Re: Barangaroo Concept (MP06_0162 MOD 9 - OBJECTION)

RE. Barangaroo Concept Plan (Mod 9): Central Barangaroo

**SUBMISSION TO INFRASTRUCTURE NSW
BARANGAROO CONCEPT PLAN (MOD 9): CENTRAL BARANGAROO**

Re: Submission in relation to MP06_0162 MOD 9 for the modification of the Barangaroo Concept Plan

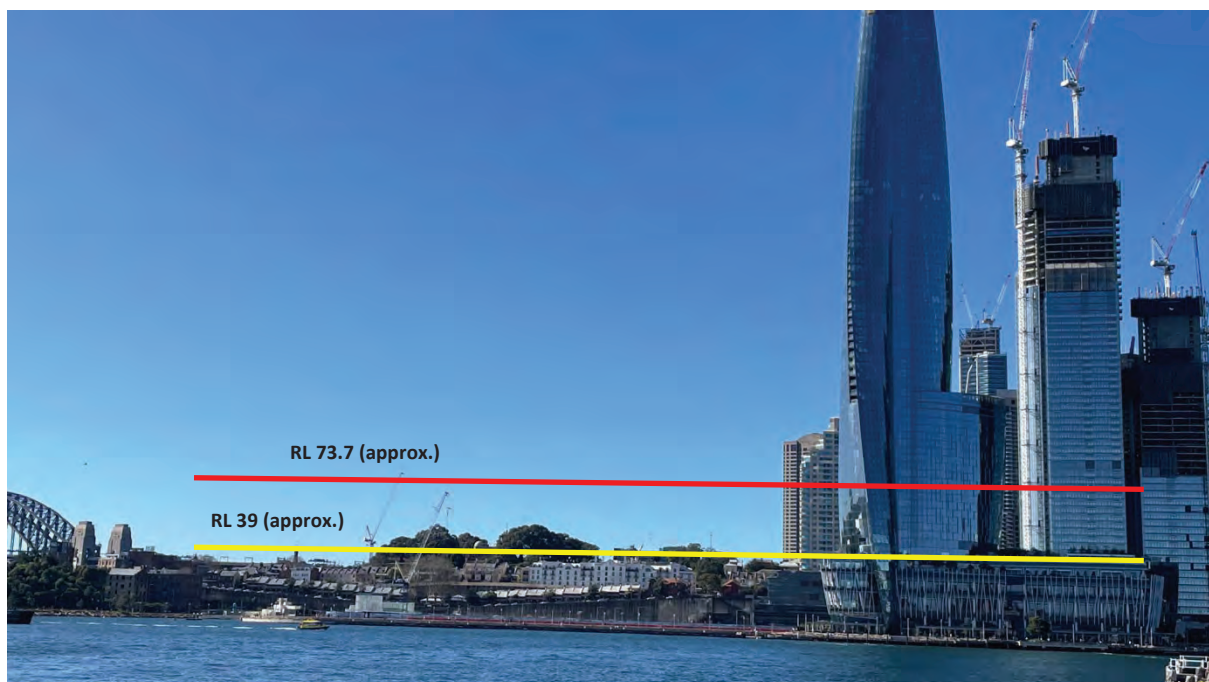
Below is a picture, taken at an elevation of RL 2.0m, of the now (July 2022) view prior to any construction within Central Barangaroo. The red line approximates the height of Block 7 (RL 73.7m); the yellow line approximates an of RL 39m. For comparison, the Crown Building has an RL of 275m

This photo is backed up by the **Barangaroo Modification 9: View and Visual Impact Assessment Report** (pp 94-97)

The montages on page 97 of the report clearly illustrates the before and after visual impact of the 2014 and 2021 height modifications. It can be clearly seen that the impact of 2021 increased heights (especially of Block 7) on views from the Pymont peninsular is excessive and unwarranted.

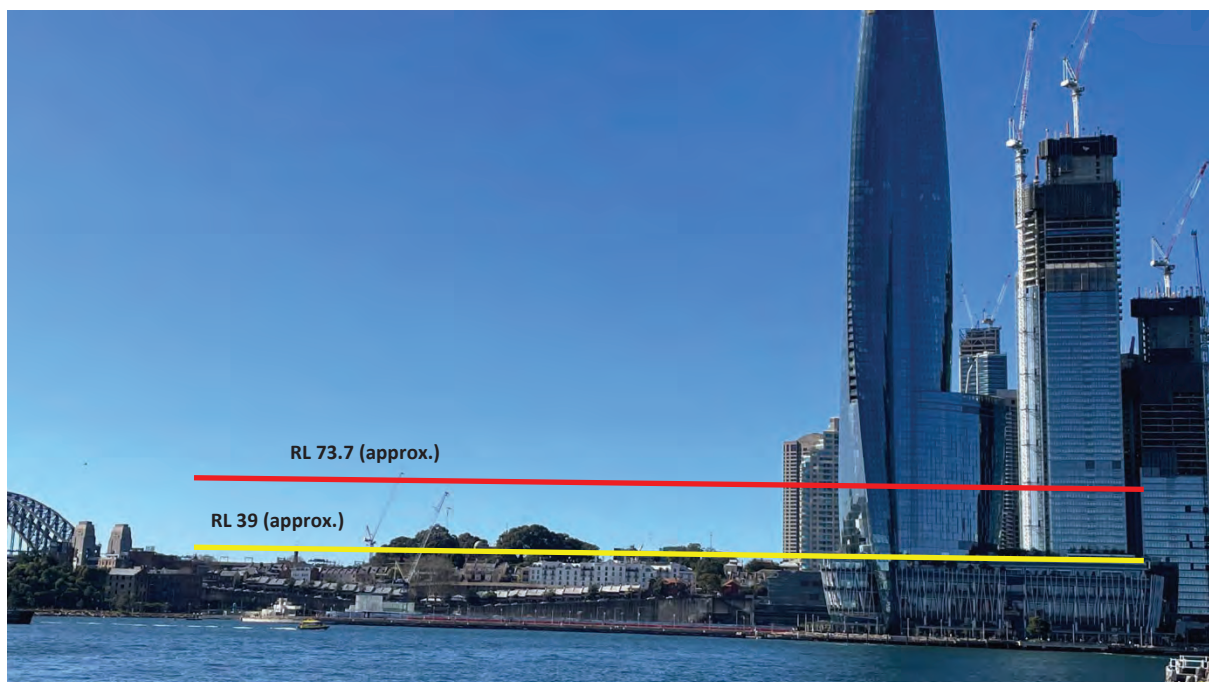
Below is a picture, taken at an elevation of RL 2.0m, of the now (July 2022) view prior to any construction within Central Barangaroo. The red line approximates the height of Block 7 (RL 73.7m); the yellow line approximates an of RL 39m. For comparison, the Crown Building has an RL of 275m

This photo is backed up by the **Barangaroo Modification 9: View and Visual Impact Assessment Report** (pp 94-97)

The montages on page 97 of the report clearly illustrates the before and after visual impact of the 2014 and 2021 height modifications. It can be clearly seen that the impact of 2021 increased heights (especially of Block 7) on views from the Pymont peninsular is excessive and unwarranted.

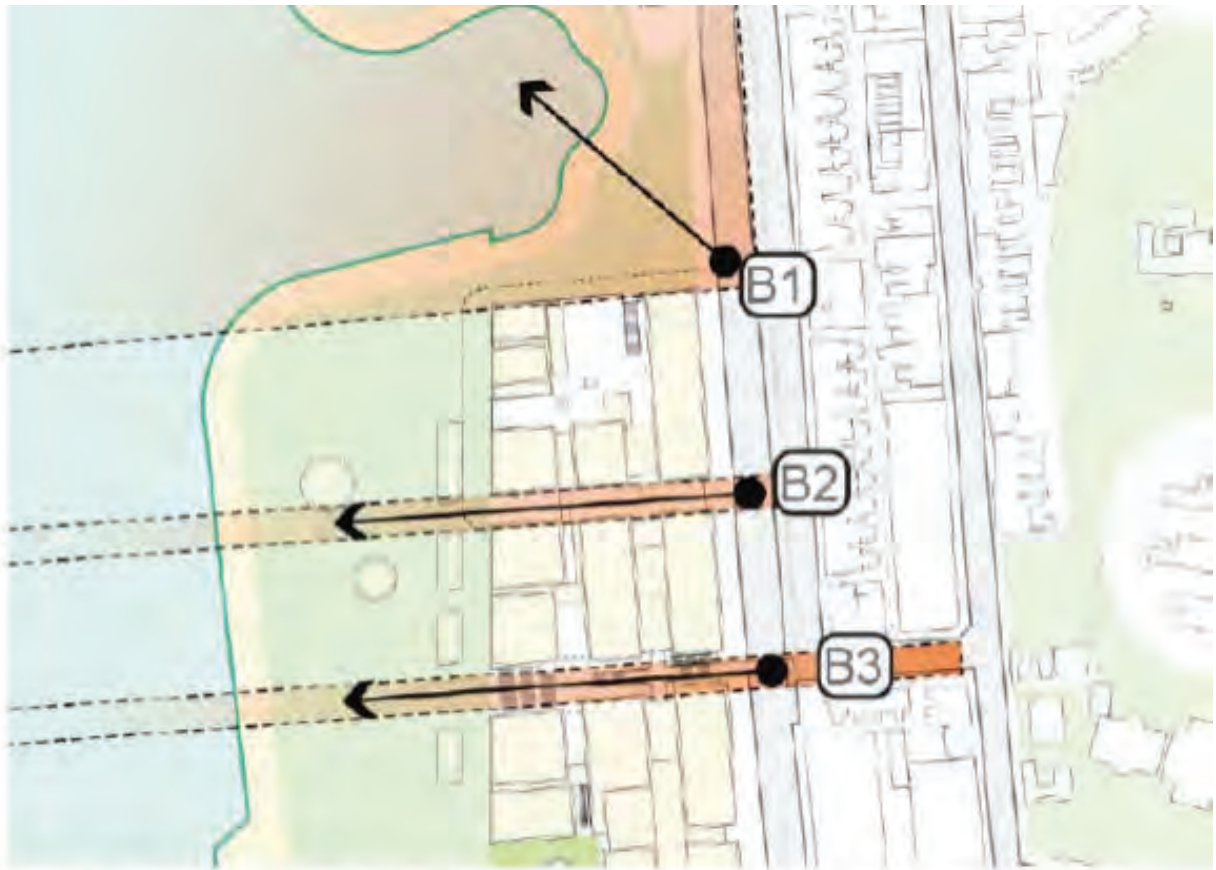
MOD 8 diminished and degraded the panorama seen from Observatory Hill. MOD 8 proposed varying heights for Central Barangaroo buildings so that a quarter of the buildings were to be 35 metres high. The three-quarters of the buildings that were lower would have retained some visual connections for Observatory Hill with the Balmain shoreline, the expanse of water that continues around to Rozelle Bay, and the buildings and streets of East Balmain. Adding three metres to the height of the envelope and building to that height across Central Barangaroo effectively removes this visual connection which has always been an essential part of this panorama.

BLOCK 7 DEVELOPMENT CONTROLS

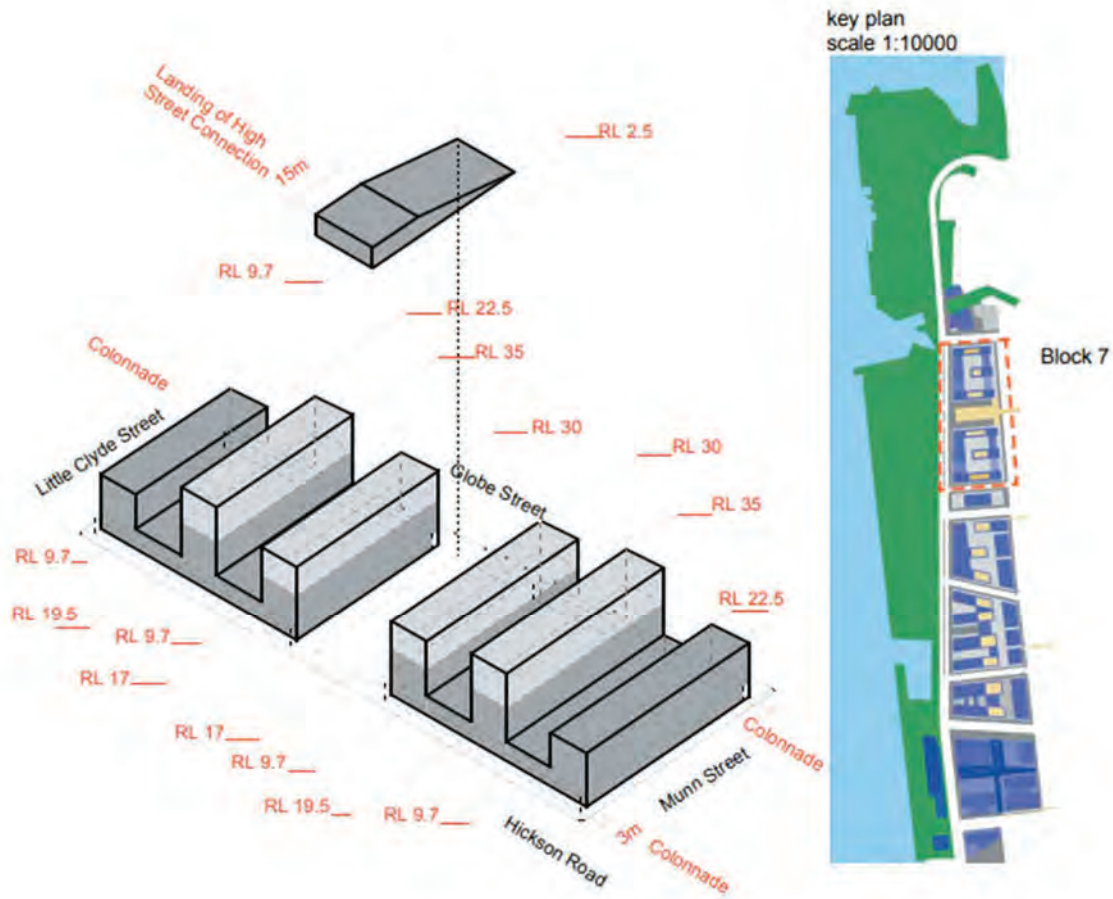
Note the predominant height of the development controls on Block 7 is 9.7 metres. This is very similar to the height of the lowest point of High Street and this control is critical in allowing

Figure 12. Revised Development Blocks

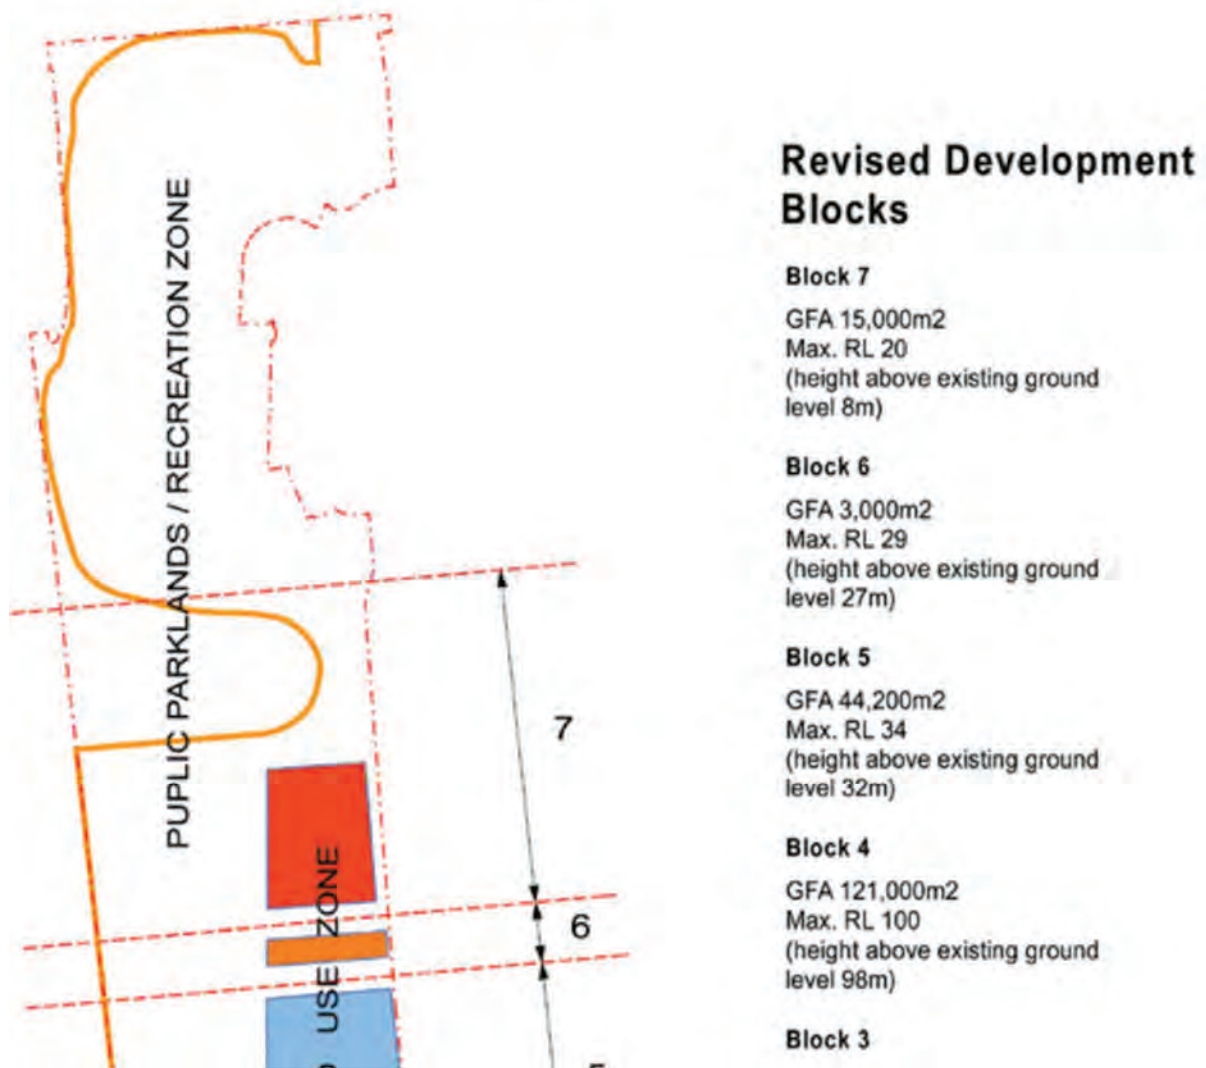
Modification 3 made several changes to Block 7. It proposed a reduction in the block area from 11,922 to 5,960 and a lowering of the maximum height to RL20.

Using the GFA to block area, we derive an FSR of 2.52 implying a maximum height across the entire envelope of 12.31 metres.

Figure 5 | The location and design of Barton Street (highlighted blue) (Base source: Proponent's EA)

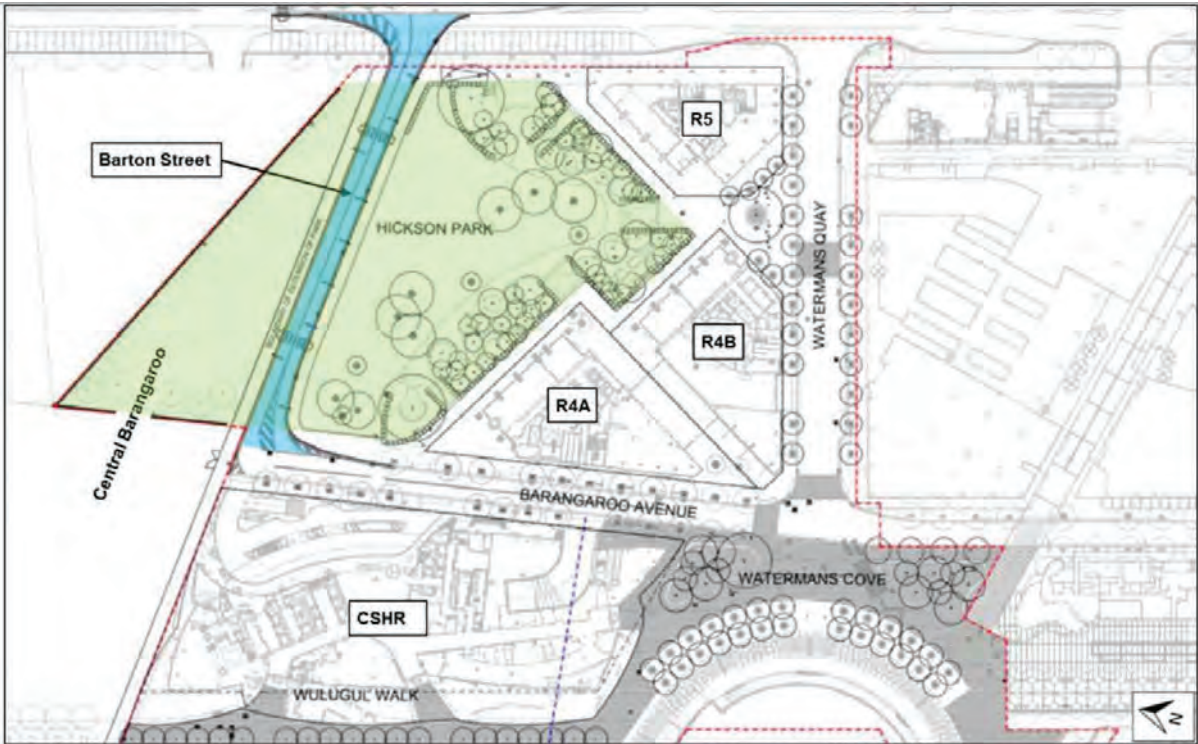
The Concept Approval allows for the construction of a temporary road (Barton Street) for the sole use of construction vehicles during the development of Barangaroo South and Central Barangaroo. The temporary road has an east-west orientation, is located within Hickson Park and is to be removed following completion of CSHR and Barangaroo Avenue.

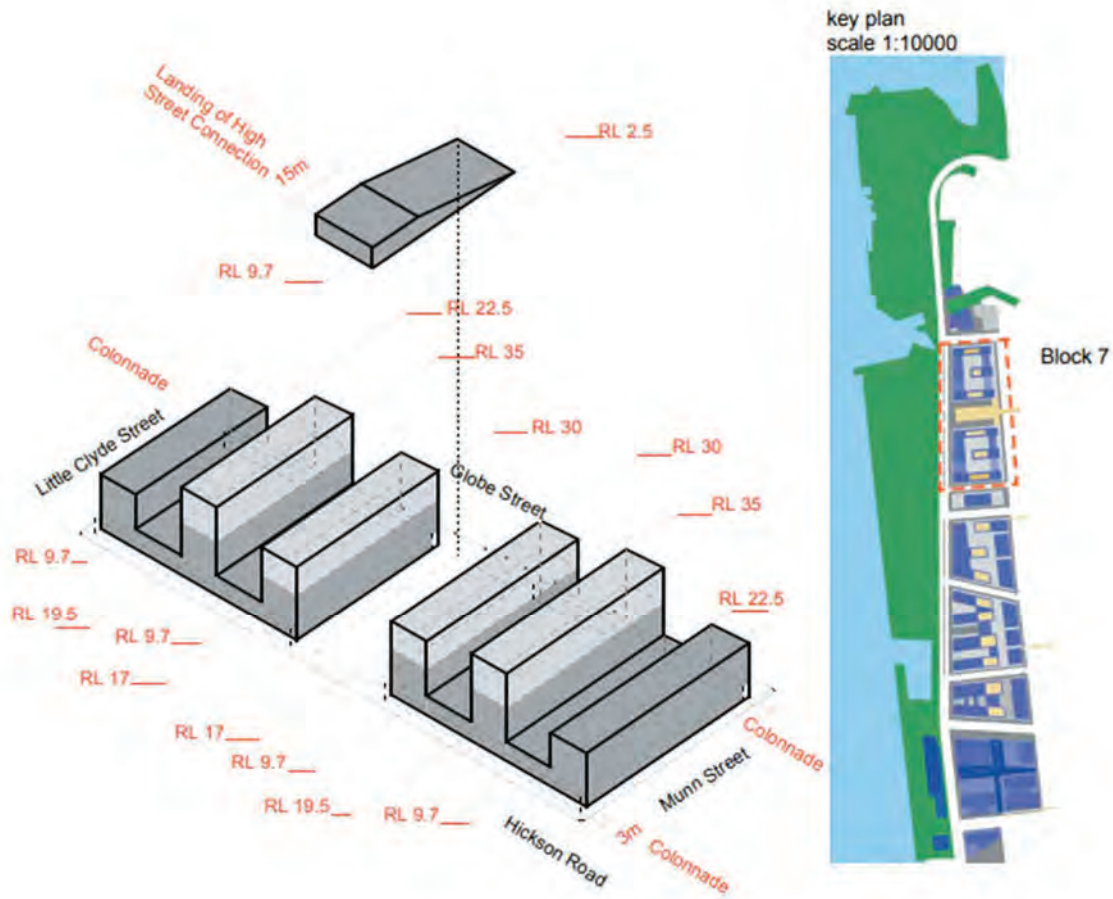
Note the predominant height of the development controls on Block 7 is 9.7 metres. This is very similar to the height of the lowest point of High Street and this control is critical in allowing

Figure 12 Existing Height of Buildings Map (west elevation)

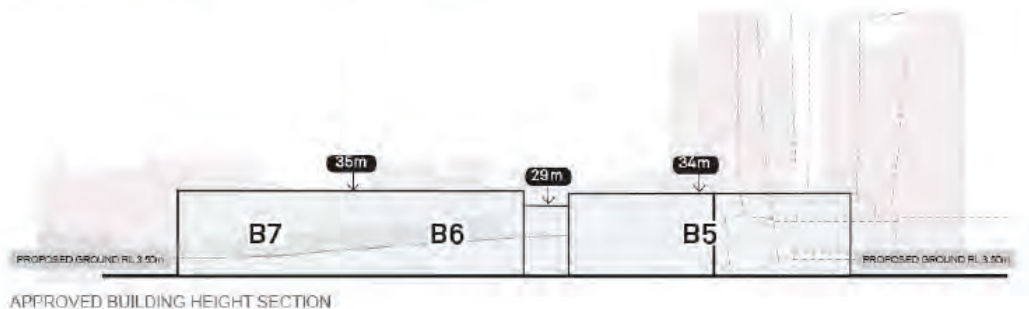
- The application raises building heights to eliminate protected views as shown in Figure 12 Appendix U. It is a breathtaking abomination against the approved Central Barangaroo built environment and travestying the Sydney Harbour Foreshores, heritage vistas and the amenity rights of the public and the residents of Millers Point.

- The depictions and figures in the application distort the 'existing heights' (eg. Figure 12 Appendix U shows Block 6 at RL29m as part of Block 7 at RL35m) and do not show the built-form that the proponents propose, but rather the nominal outlines, and with lots of words of empty
